PIC18F2410/2510/4410/4510 Rev. B4 Silicon Errata

The PIC18F2410/2510/4410/4510 Rev. B4 parts you have received conform functionally to the Device Data Sheet (DS39636D), except for the anomalies described below. Any Data Sheet Clarification issues related to the PIC18F2410/2510/4410/4510 will be reported in a separate Data Sheet errata. Please check the Microchip web site for any existing issues.

The following silicon errata apply only to PIC18F2410/2510/4410/4510 devices with these Device/Revision IDs:

FIGURE 1: SCK PULSE VARIATION USING TIMER2/2

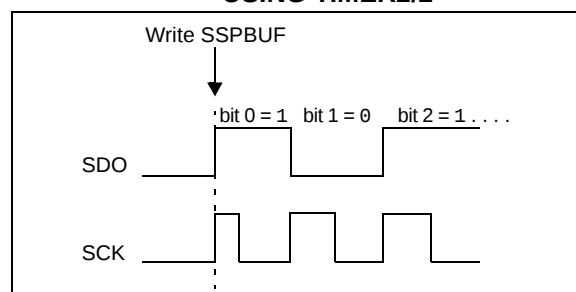
When the SPI is using Timer2/2 as the clock source, a shorter than expected SCK pulse may occur on the first bit of the transmitted/received data (Figure 1).

To avoid producing the short pulse, turn off Timer2 and clear the TMR2 register, load the SSPBUF with the data to transmit and then turn Timer2 back on. Refer to Example 1 for sample code.
